[1] REDLINE REVISION 2/1/06 TEDD APPROVAL JAH 2/16/06

REVISIONS	
B 8-5-05	REBUILD SIGNAL AND INSTALL INTERCONNECT SHA NO.AT7205185 RRZ
A 6-9-97	ASBUILT SHA NO. AW 101-501-585 RRZ

MD 322 AND GLEBE RD

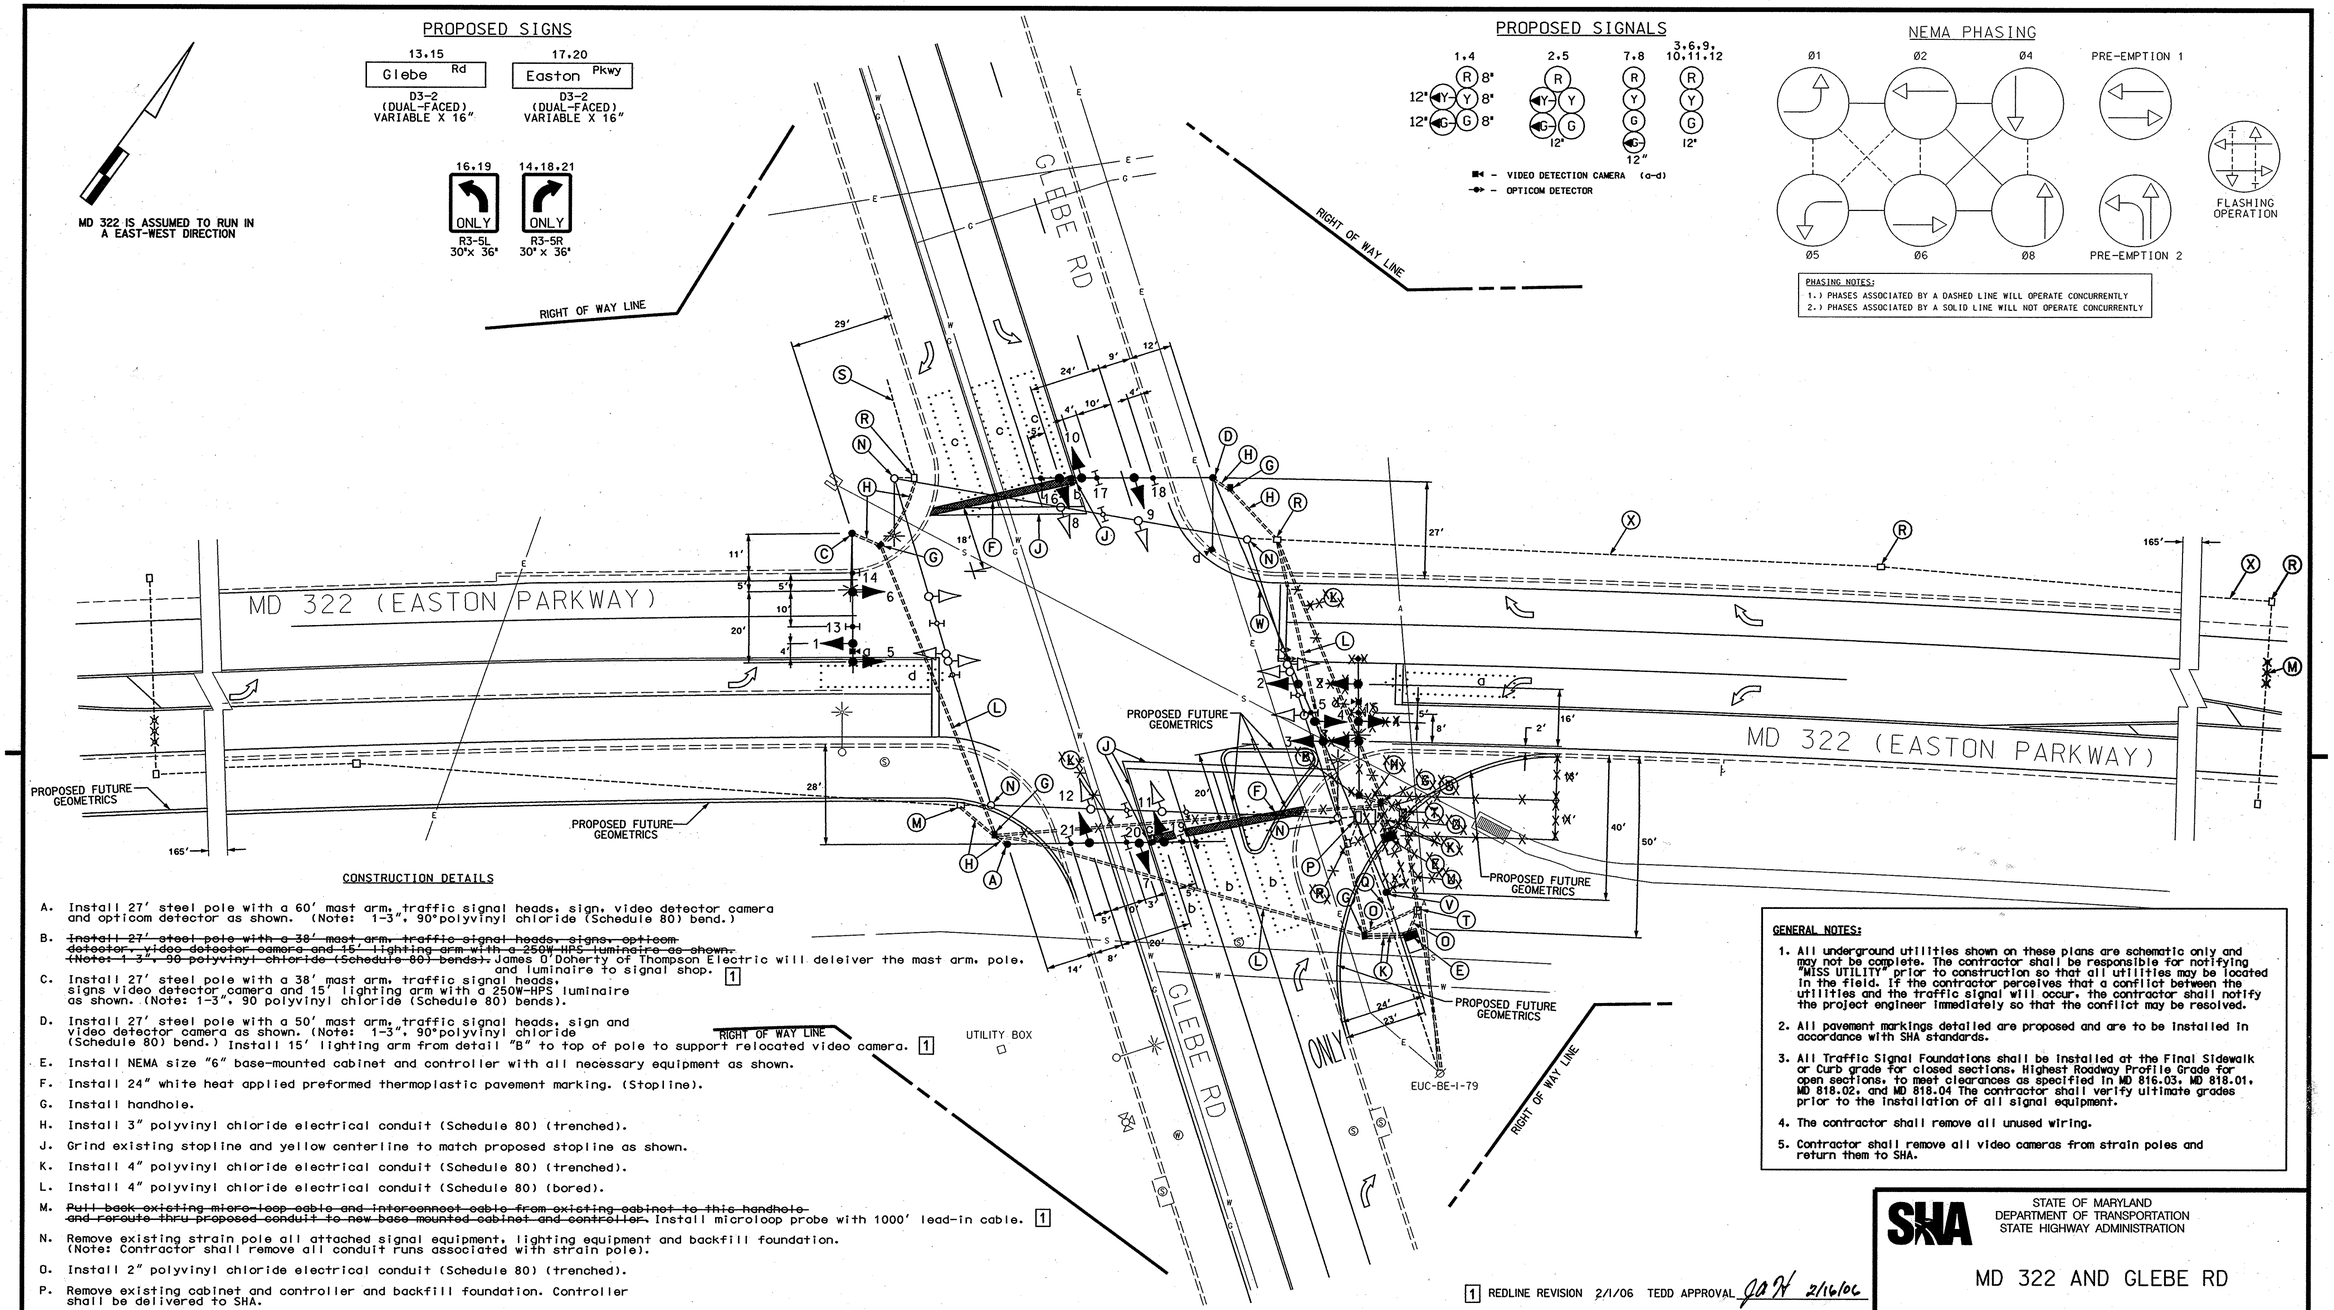
B. ~~Install 27' steel pole with a 38' mast arm, traffic signal heads, signs, opticom detector, video detector camera and 15' lighting arm with a 250W-HPS luminaire as shown. (Note: 1-3", 90 polyvinyl chloride (Schedule 80) bends).~~ James O'Doherty of Thompson Electric will deleiver the mast arm, pole, and luminaire to signal shop. [1]

D. Install 27' steel pole with a 50' mast arm, traffic signal heads, sign and video detector camera as shown. (Note: 1-3", 90°polyvinyl chloride (Schedule 80) bend.) Install 15' lighting arm from detail "B" to top of pole to support relocated video camera. [1]

M. ~~Pull back existing micro-loop cable and interconnect cable from existing cabinet to this handhole and reroute thru proposed conduit to new base mounted cabinet and controller.~~ Install microloop probe with 1000' lead-in cable. [1]

V. Install 40' class 2 wood pole with back guy as shown. [1]

W. Install 3/8" steel span wire with 1/4" tether wire to support signal heads and opticom detector eye. [1]

X. Use existing conduit. [1]
